MONTGOMERY COUNTY HISTORIC PRESERVATION COMMISSION
STAFF REPORT

Address:	10009 Menlo Ave., Silver Spring	Meeting Date:	3/26/2025
Resource:	1935+ (Nominal) Capitol View Park Historic District	Report Date:	3/19/2025
Applicant:	Nick Steiner	Public Notice:	3/12/2025
Review:	HAWP	Tax Credit:	No
Case No.:	1106777	Staff:	Devon Murtha
PROPOSAL:	New rear addition

Figure 9: Plan view of the proposed addition (Applicant, 2025).

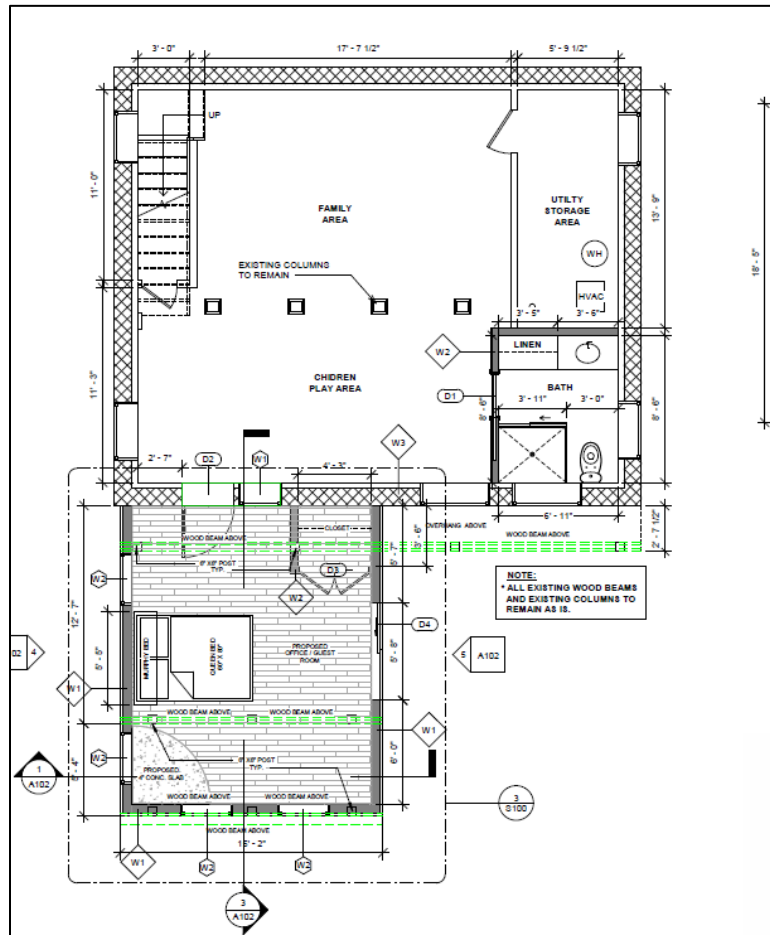
The *Standards* emphasizes the need for alternations and new construction to compatible with the massing, size, scale, and architectural features to protect the character of historic properties and the surrounding environment. Staff finds that the applicant's proposal for the one-story addition meets these standards. The footprint for the proposed addition is significantly smaller than the footprint of the house and will be located on the basement level at the rear of the property (*Figure 9*). The proposed materials, including HardiPlank fiber cement lap siding and vinyl windows, closely match the materials of the existing house and the surrounding district.
